Addendum No. 1

Bid Opportunity: 7159-RW-22 – Smithson PS Office and HVAC Upgrades.

Closing Date: Monday, March 14th, 2022 2:00 PM

drawing number
A0.0

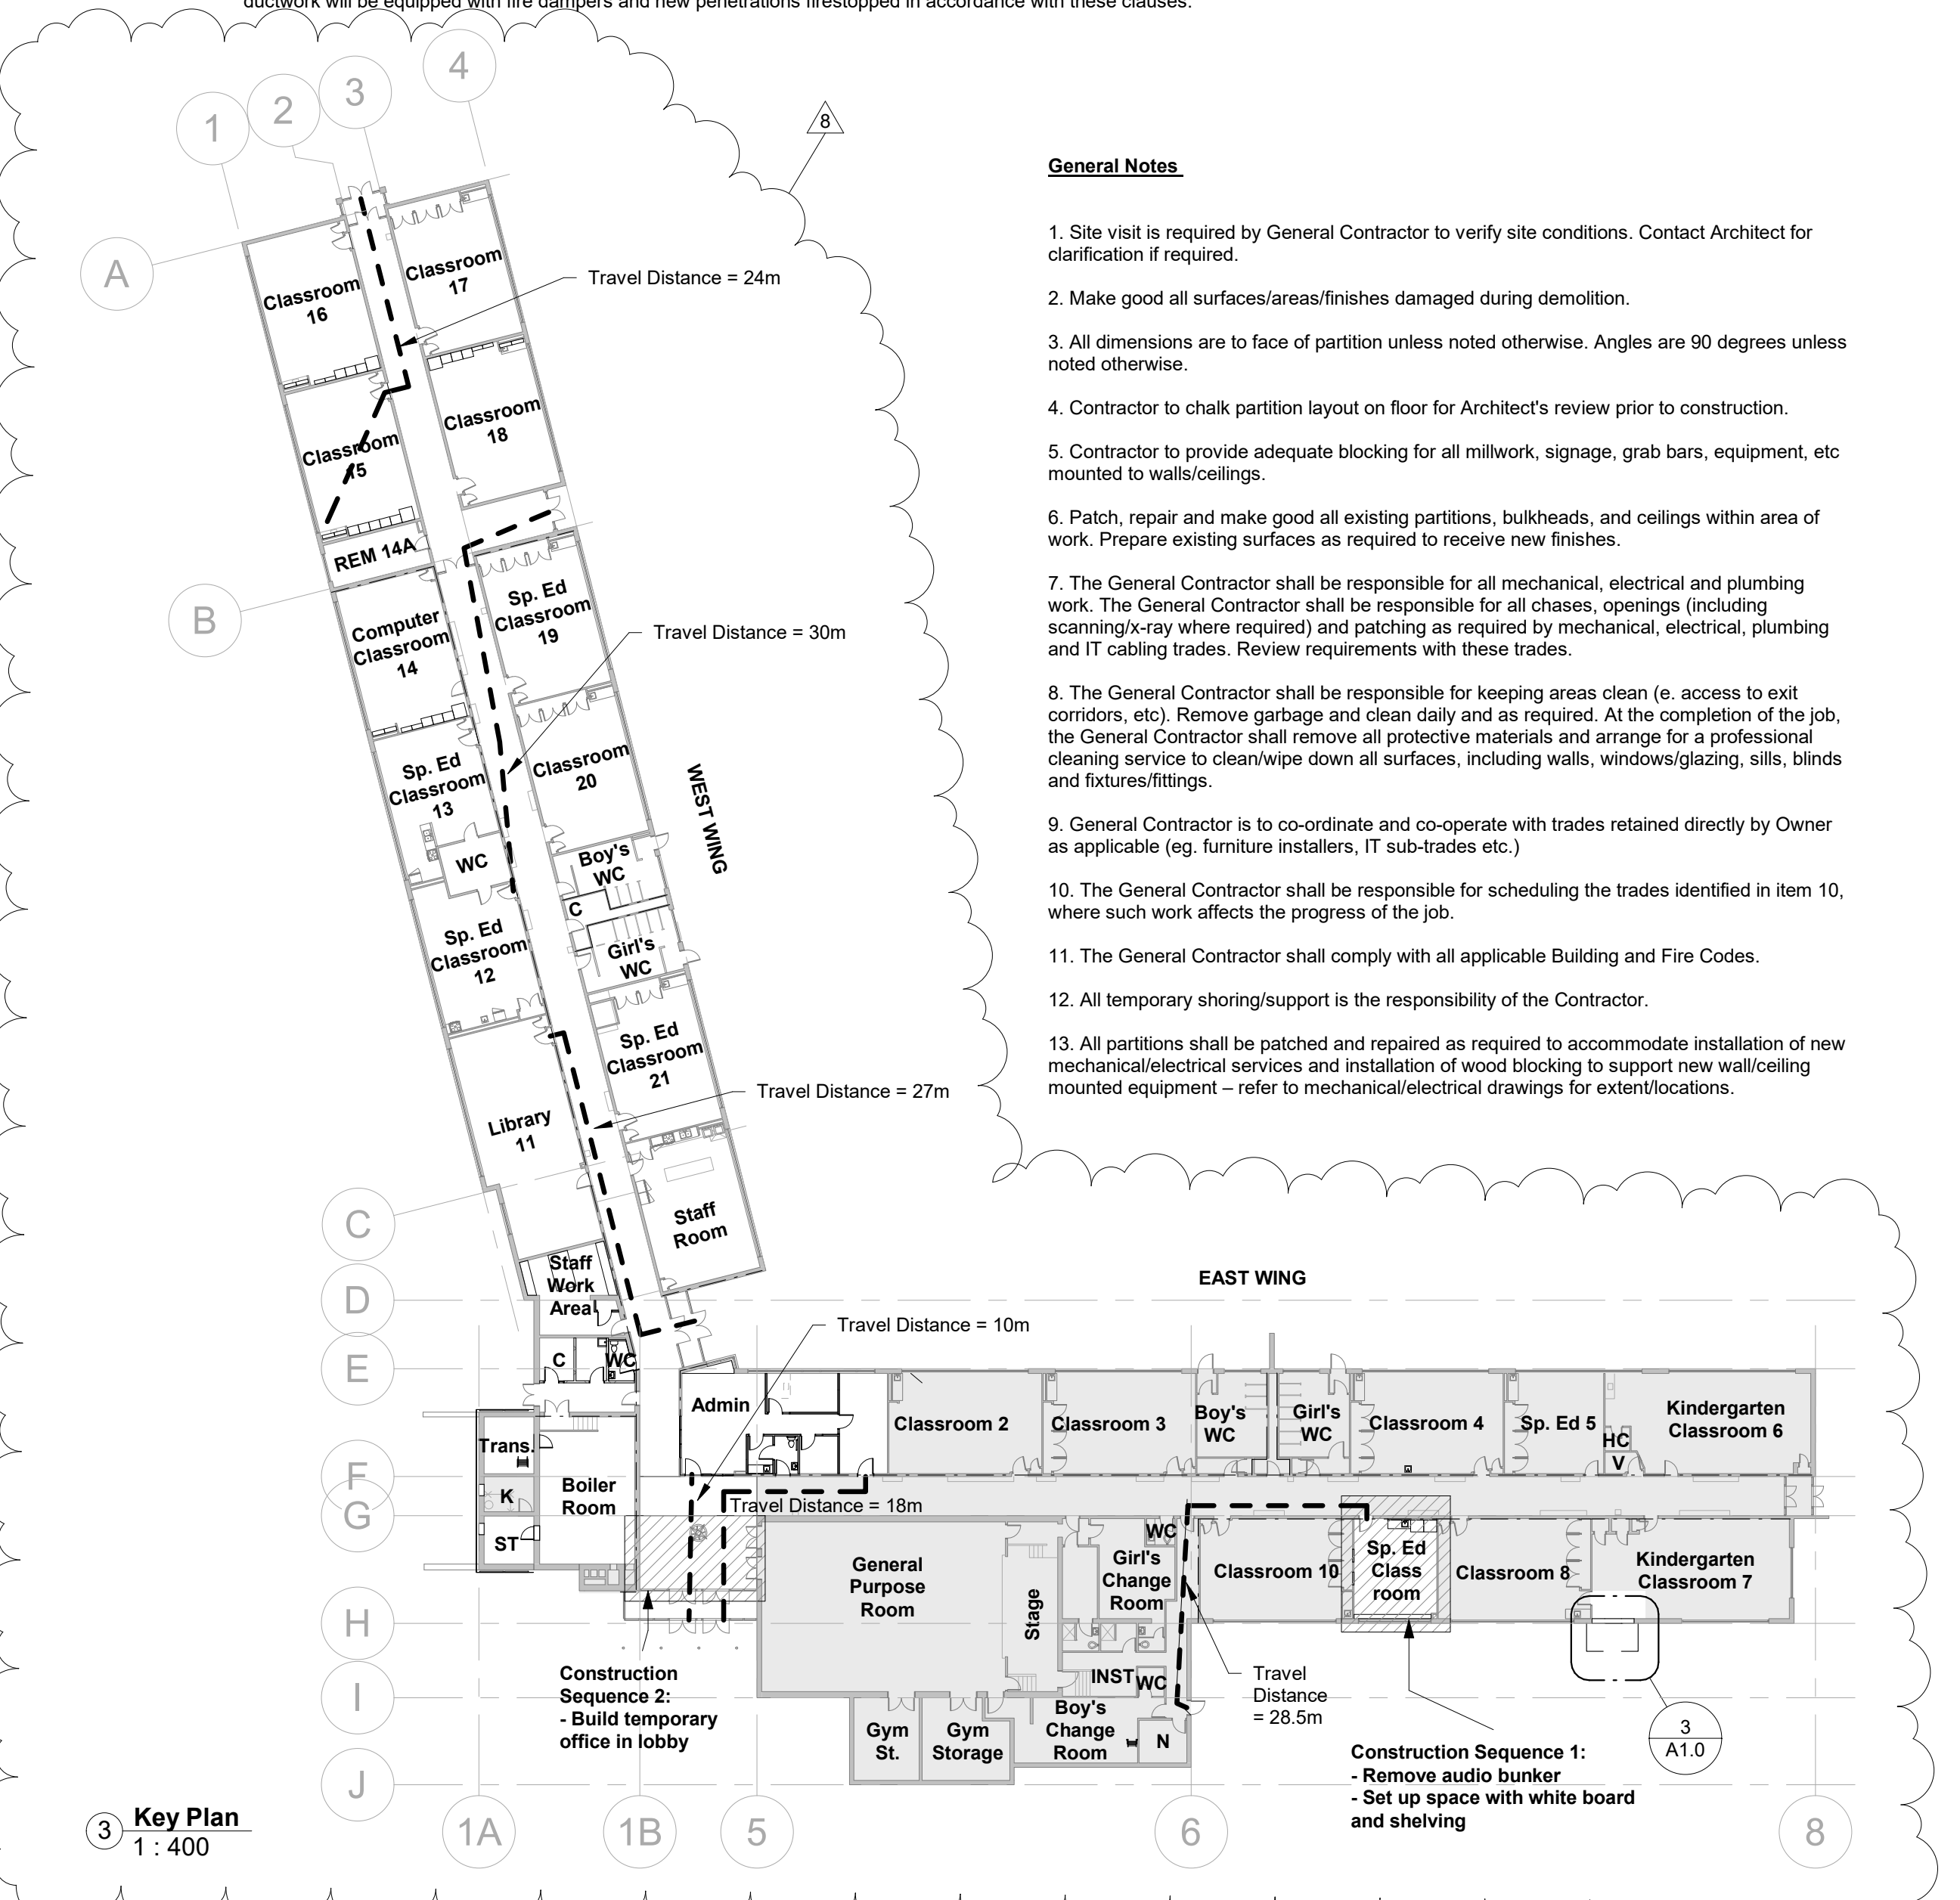
Refer to attached A0.0 Cover Sheet for Revised Detail 3 (Revised Corridor Fire Rating).

Demolition RCP

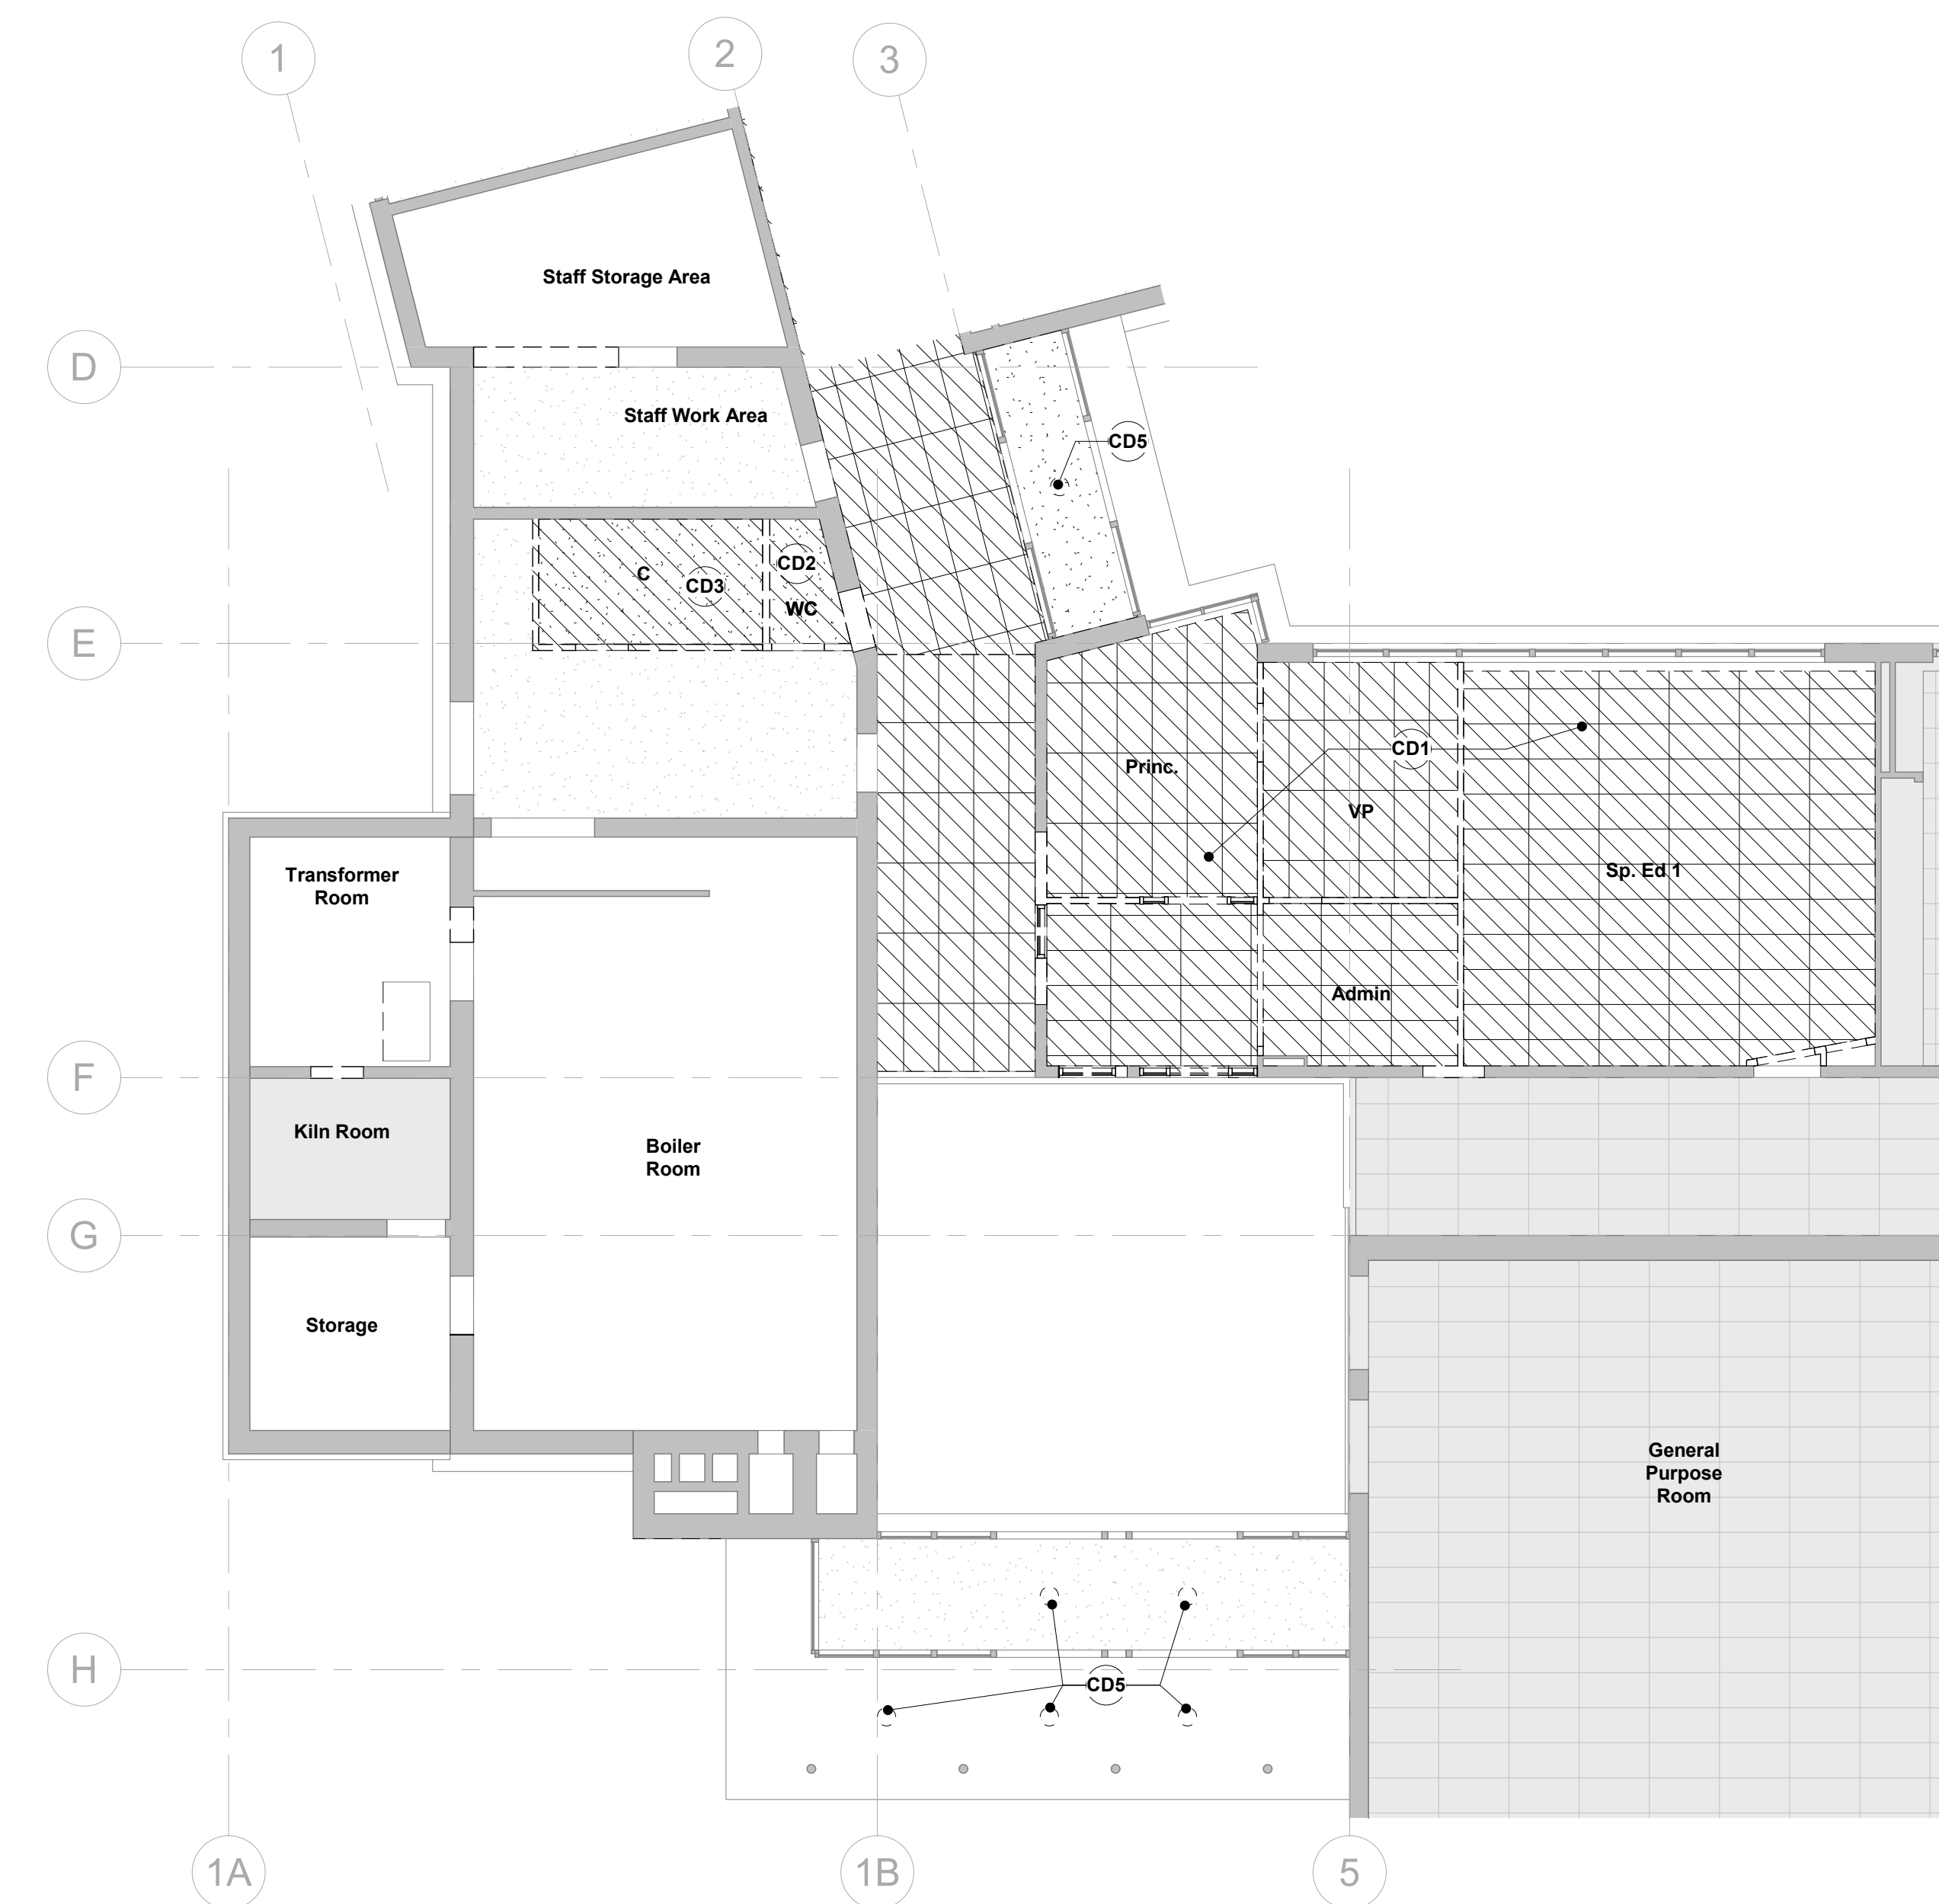
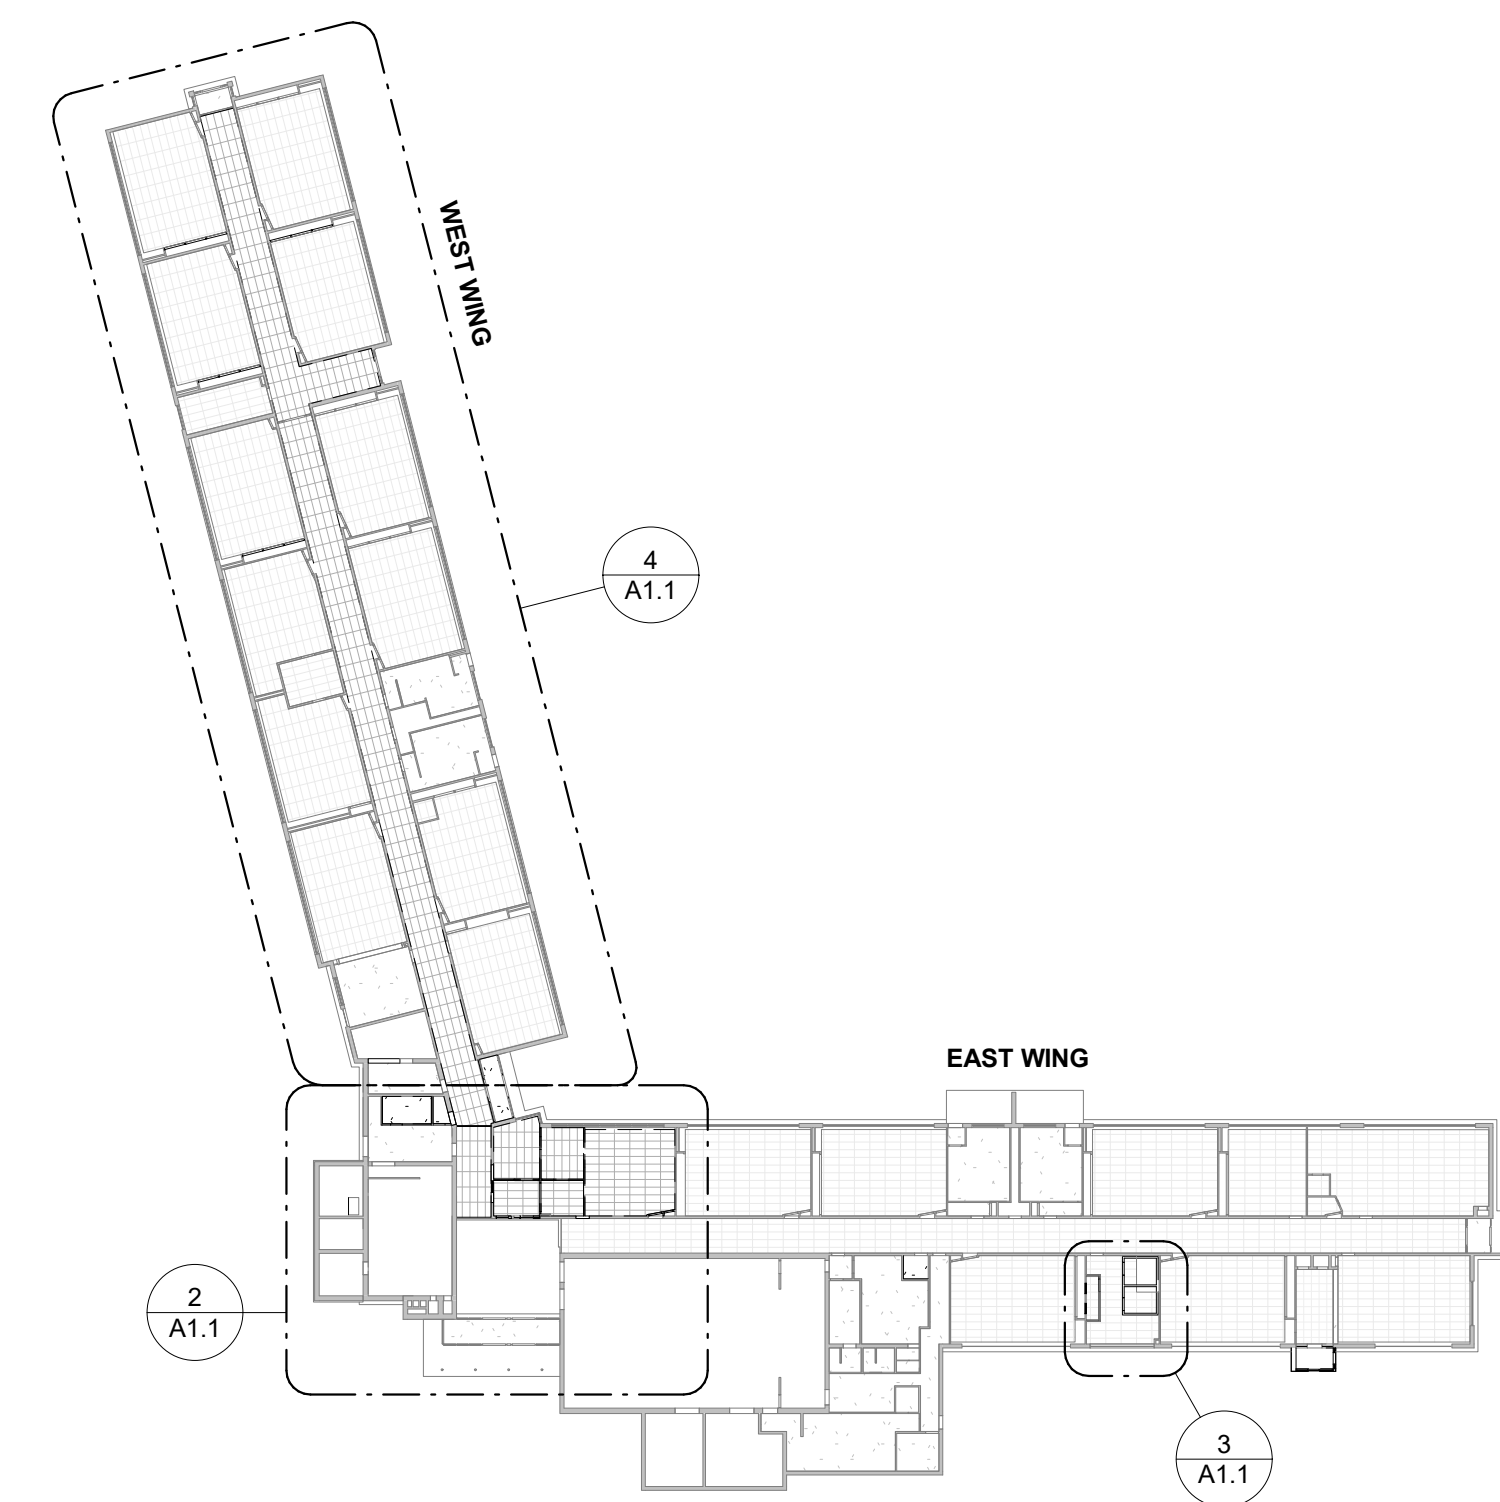
Refer to attached A1.1 Demolition RCP for Added GWB ceiling area to be removed and Added Ceiling Demolition Note.
